our reference: 22000129-R-02
your reference:

Review of Surface and Ground Water Quality: Windsor Bridge

As requested, SEEC has coordinated a review of the Water Quality Management Program (WQMP) for the Windsor Bridge Replacement Project prepared by Jacobs on behalf of Transport for NSW. The WQMP describes the required water quality sampling and testing regime to determine if the proposed construction of the new bridge over the Hawkesbury River at Windsor has impacted local surface and ground water environments.

Figure 14: Plot of Aluminum concentrations at the north bank locations, post construction.

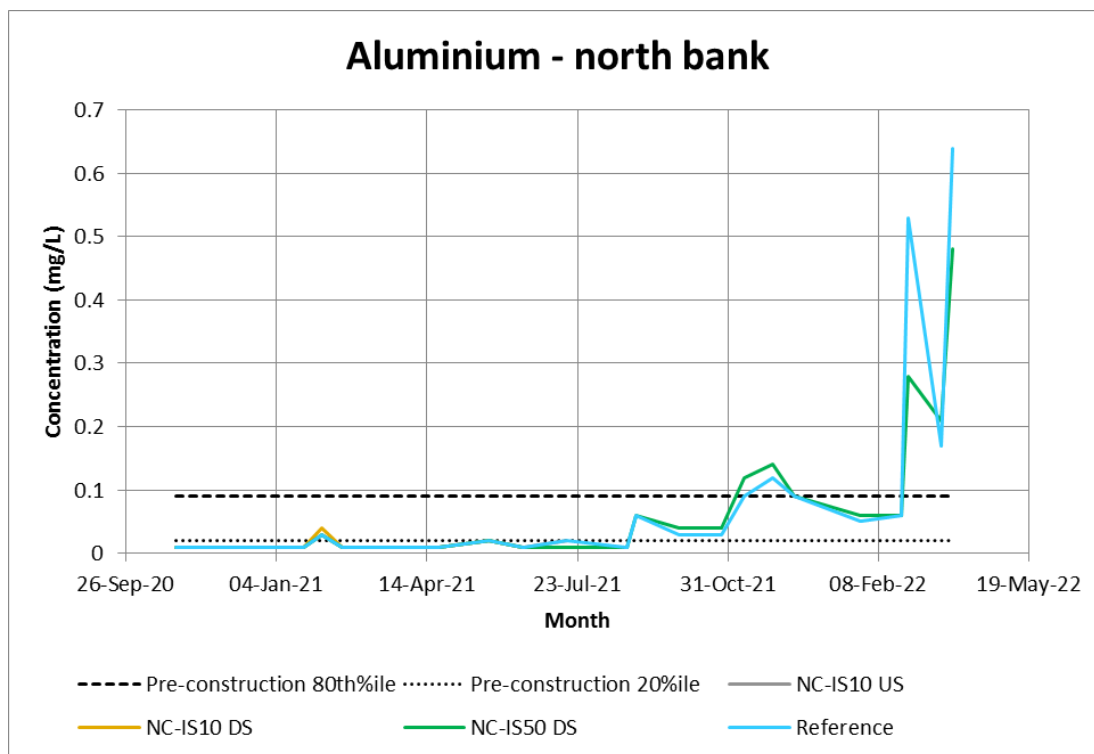
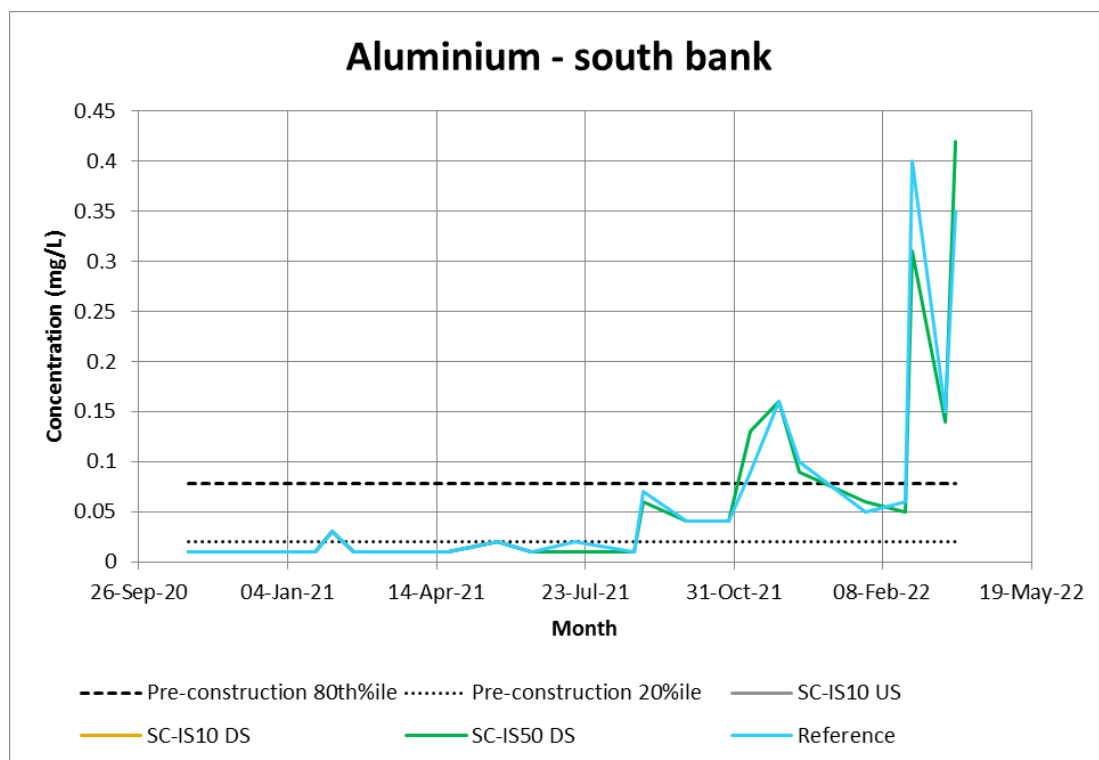
Aluminium levels were below the SSTV and ANZECC trigger value of 0.055mg/L between September 2020 and August 2021 (i.e. during the construction period). However after this date aluminium levels spiked above the SSTV and the ANZECC trigger levels. This increase also occurred at the upstream reference site indicating that it is unlikely that the project was the cause of the observed change in aluminium concentrations.

Figure 16: Plot of Iron concentrations at the north bank locations, post construction.

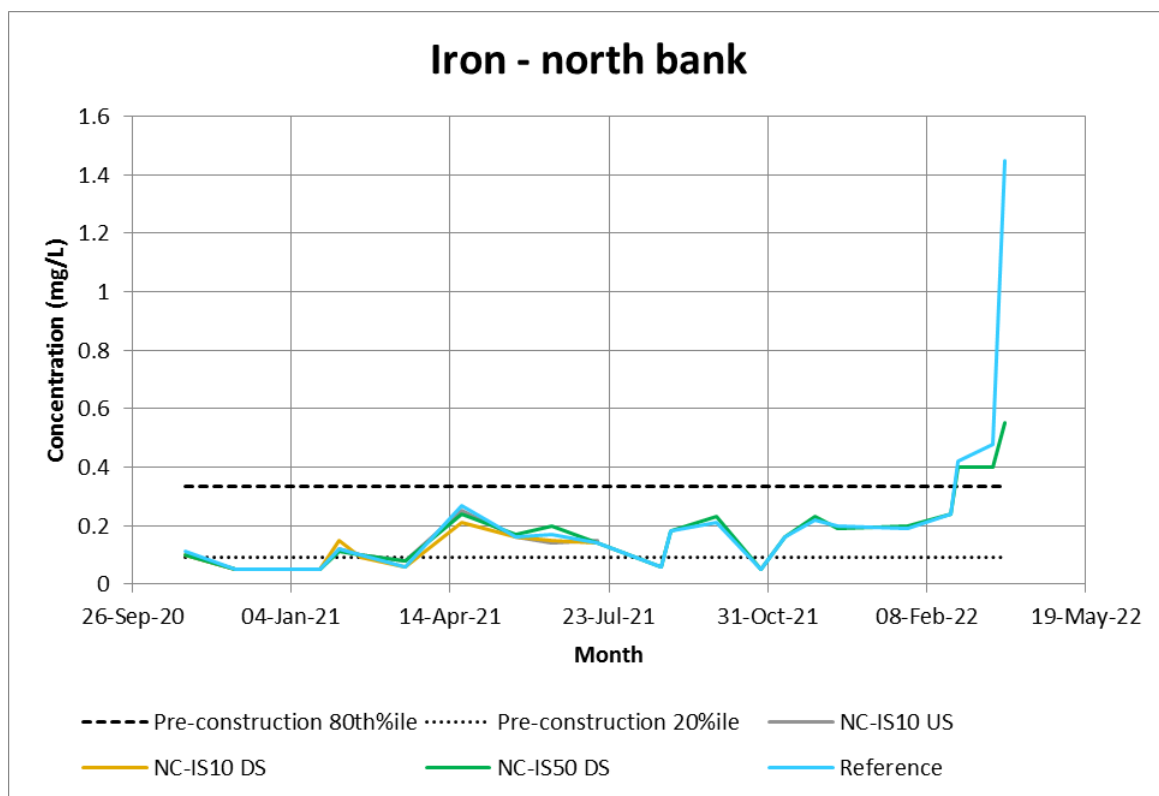
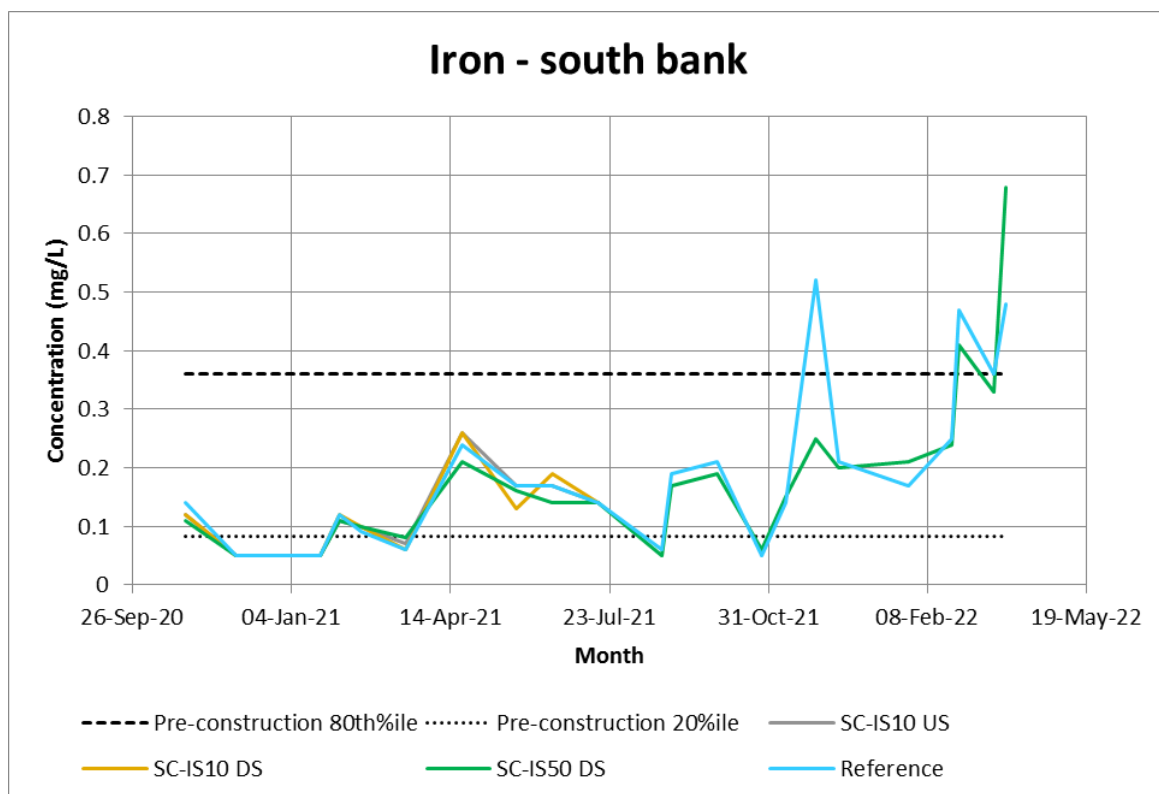
Similar to the observed aluminium concentrations, iron levels were below the ANZECC trigger value of 0.3mg/L and then spiked towards the end of the

monitoring period. Prior to this time there were no increases above the SSTV. The final observed iron concentration for the south bank exceeded the value recorded at the reference site and at the upstream wet weather monitoring site (SC-CS2). As the monitoring occurred after a major flood event (590mm recorded in March 2022) it is difficult to conclude that the increase is based solely as a result of the project when flood water would likely still be contaminated from runoff from an extended catchment well upstream of the project site.
